PREVOST

WARRANTY BULLETIN

WB16-02D

DATE :	MAY 2016	SECTION :	06 - Electrical
EXPIRATION:	MAY 2018		
SUBJECT :	CHARGING SYSTEM IMPROVEMENT

FIGURE 2

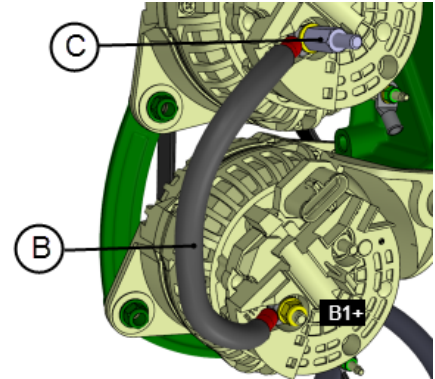
2. Disconnect jumper cable **B** from the upper alternator **B1+** stud terminal. To do so, unscrew and remove stud adapter **C** and flat washer.
3. Disconnect jumper cable **B** from the lower alternator **B1+** stud terminal. To do so, remove hex nut and washer.

4. Inspect the stud adapter that you have just removed from the upper alternator. The hex part of the stud adapter must measure 1 inch long.
5. If the stud adapter hex part is **too short** (**about 13/16"**), install stud adapter #060297 included in kit #7770176.

FIGURE 7

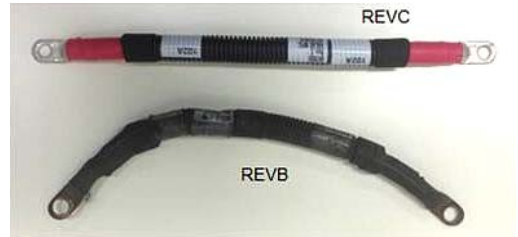
Rev.B diameter of the through hole is too large, reducing contact surface with the stud and the nut thus reducing electrical conductivity between the lug and the alternator stud (FIGURE 7).

FIGURE 8

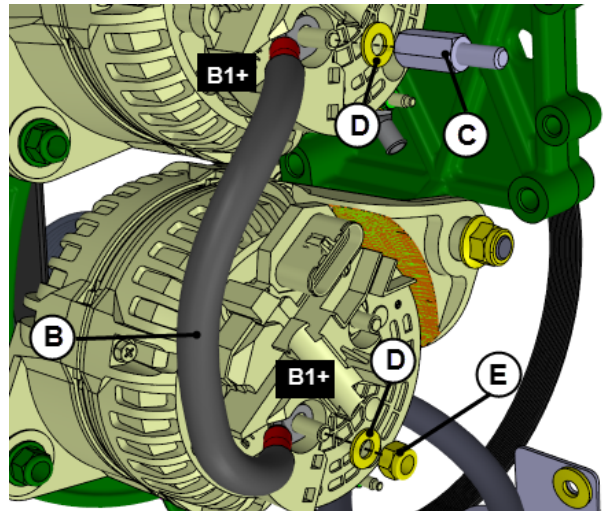
REVISION D: THIS WARRANTY BULLETIN SUPERSEDES PREVIOUS VERSION.
 Released: Jan.2017 Stud adapter #564590 canceled. New improved stud adapter is #060297. Stud adapter and M8 nut torque was 10 lbf-ft, increased to 11 lbf-ft.

7. Reinstall appropriate jumper cable **B** (i.e. rev.C) with appropriate stud adapter. Refer to FIGURE 8.

C : STUD ADAPTER #060297 torque: 10 lbf-ft

E: NUT M8 #5001787 torque: 10 lbf-ft

FIGURE 9

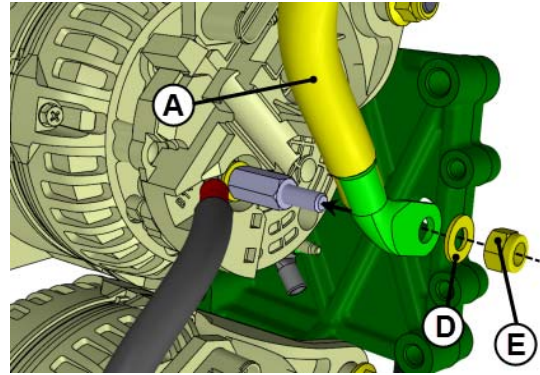
-
8. Reinstall power cable **A**. To do so, connect power cable **A** to the upper alternator **B1+** stud terminal. Refer to **FIGURE 9**.

E: NUT M8 #5001787 *torque: 10 lbf-ft*

FIGURE 14

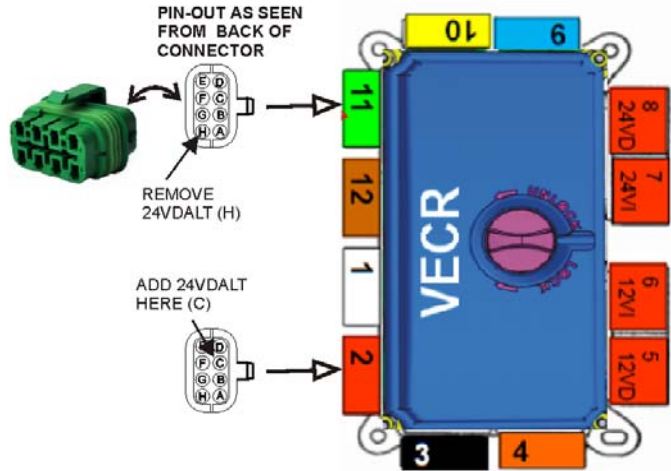
3. Using an extractor tool or a small flat blade screwdriver, remove wire 24VDALT from cavity H of connector no.11 (FIGURE 11 to FIGURE 14).

4. Relocate wire 24VDALT to cavity **C** of connector no.2 (red) on the harness.

FIGURE 16 : WIRING DIAGRAM PAGE 5.1

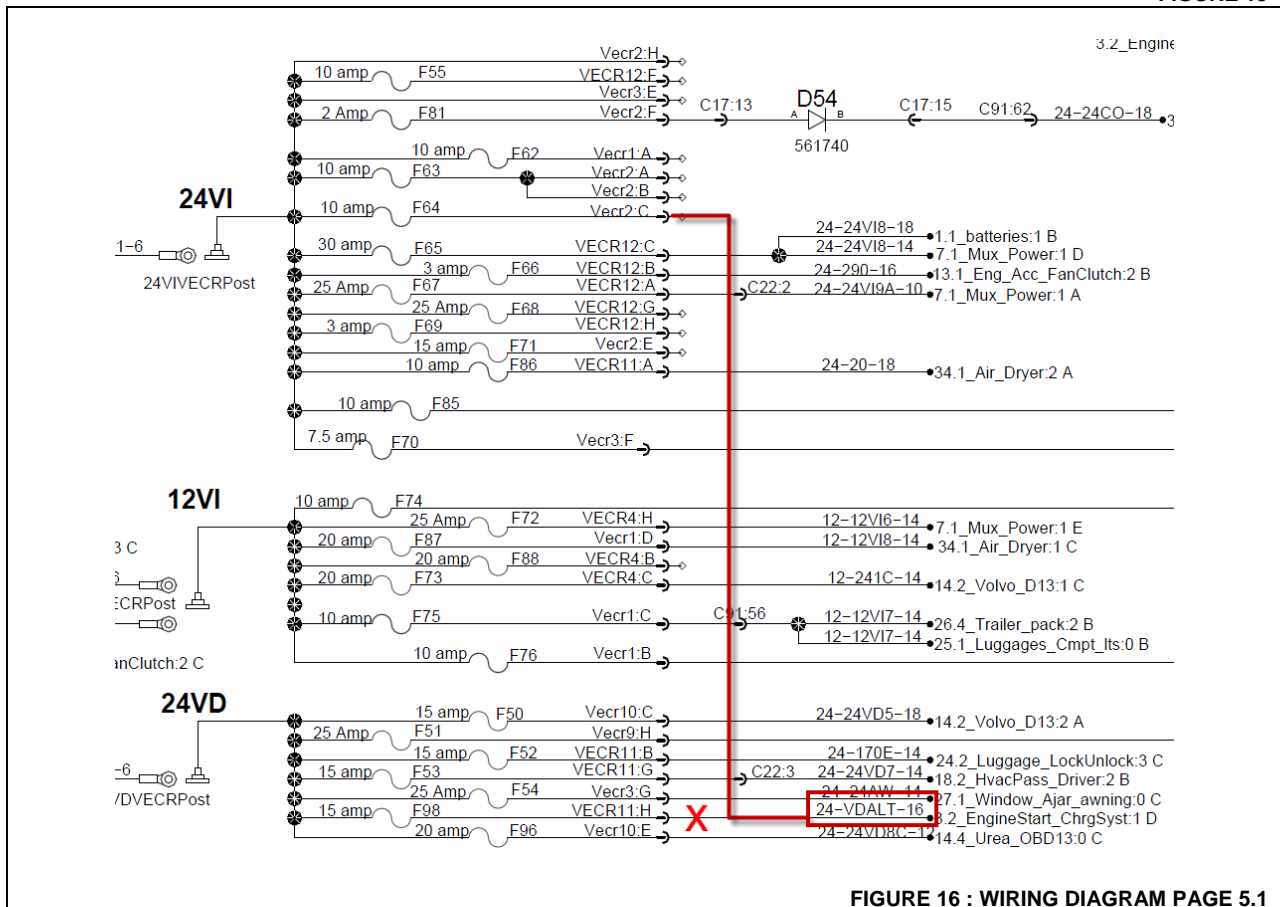
Cavity **C** of connector no.2 should be available. This branch of the circuit will be protected by 10A fuse F64 (see FIGURE 16 below).

Should cavity C not be available, refer to your vehicle wiring diagram page 5.1 to select another free cavity protected by a 10A or 15A fuse (see FIGURE 16 for reference).

FIGURE 20

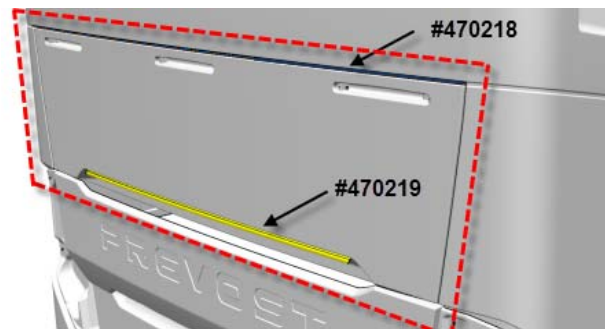
2. Clean dirt on the lower part of the **exhaust aftertreatment system ATS** access hatch as well as the area located right above the ATS access hatch (FIGURE 20). It is very important to install the drip edge on a clean surface to assure water tightness.

NOTE: FIGURE 20 shows where the drip edges will be installed.

FIGURE 40

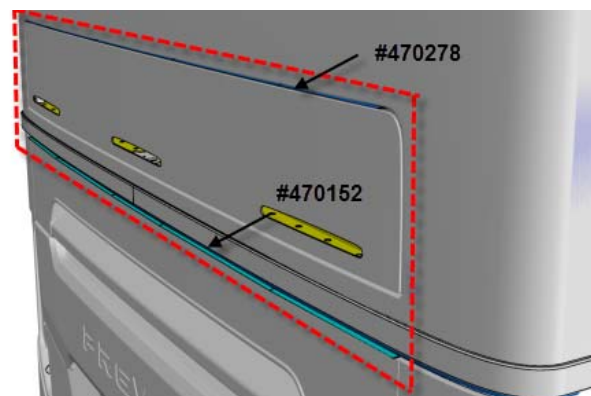
2. See on FIGURE 40 where each drip edge will be positioned. The drip edges will be fastened on the vehicle body, **not on** the ATS access hatch.

FIGURE 48

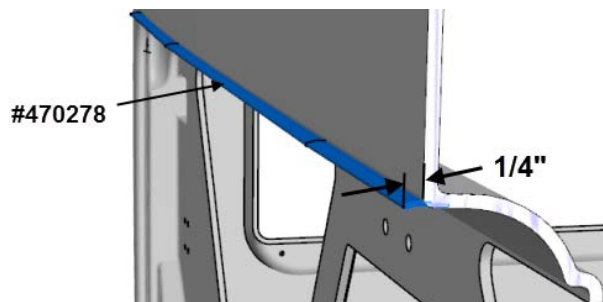
The drip edge should extend past the panel surface by **1/4"**. The goal is to prevent water/rain from dripping on the inner side of the SCR access hatch.

IMPORTANT NOTE: The drip edge must not be stuck on the vehicle body except in the middle area where the drip edge cannot be fastened with rivets. In this particular case, peel back the protective layer on the adhesive foam tape and stick to the surface.

No rivets are used to fasten the middle of the drip edge because the rivet head will interfere with the upper edge of the ATS access hatch.

FIGURE 52

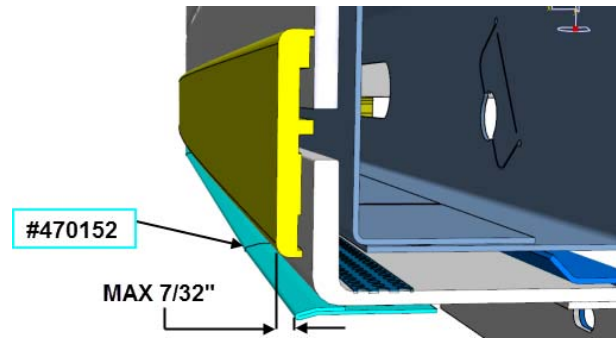
The drip edge should be shifted not more than 7/32" from the surface of the molding located above it (FIGURE 52). The goal is to prevent water from dripping on the inner side of the engine compartment door.
